UNITED STATES PATENT AND TRADEMARK OFFICE

APPLICATION NO.	FILING DATE	FIRST NAMED INVENTOR	ATTORNEY DOCKET NO.	CONFIRMATION NO.
10/763,044	01/22/2004	Olivier Pizzuto	02-RO-250	3798
23334	7590	05/23/2005	EXAMINER	
FLEIT, KAIN, GIBBONS, GUTMAN, BONGINI & BIANCO P.L. ONE BOCA COMMERCE CENTER 551 NORTHWEST 77TH STREET, SUITE 111 BOCA RATON, FL 33487			KIM, SU C	
			ART UNIT	PAPER NUMBER
			2823

Office Action Summary

FIG. 2C (PRIOR ART)

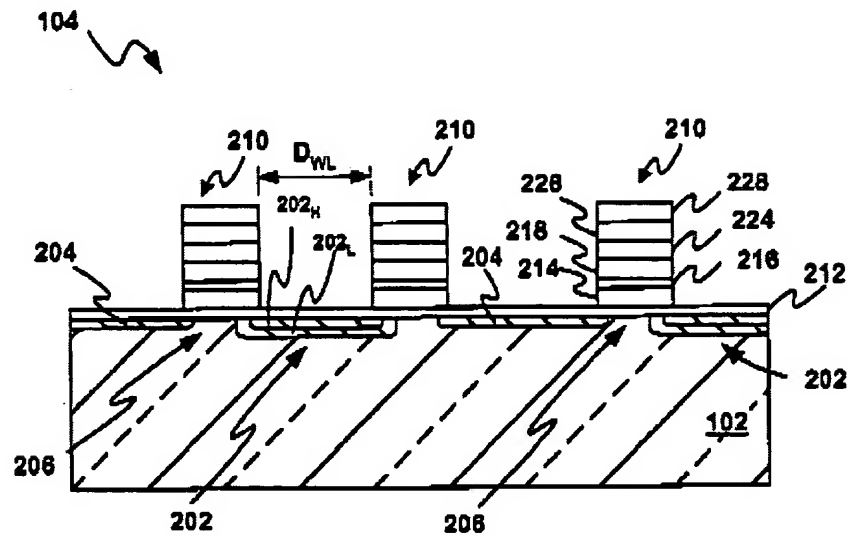
Subramanian discloses a method for flash memory process as claimed.

See all FIGS, where Subramanian teaches the following claims.

Pertaining to claim 1, Subramanian discloses a method for producing a flash memory comprising:

forming at least two adjacent rows of precursor stacks of floating gate transistors **214** on a semiconductor substrate **102**, with the precursor stacks **210** being at least partially covered by a protective resin **212 & 318** and being separated by a formation zone for a source line **202** ;

forming a trench **202** in the formation zone for the source line **202** by an attack of the formation zone and of the protective resin **212 & 318** so as to result in a deposit of residue from the protective resin below the precursor stacks **(Column 7 lines 26-29, please note the claim 1 directly refers to self-aligned source etching process)**;
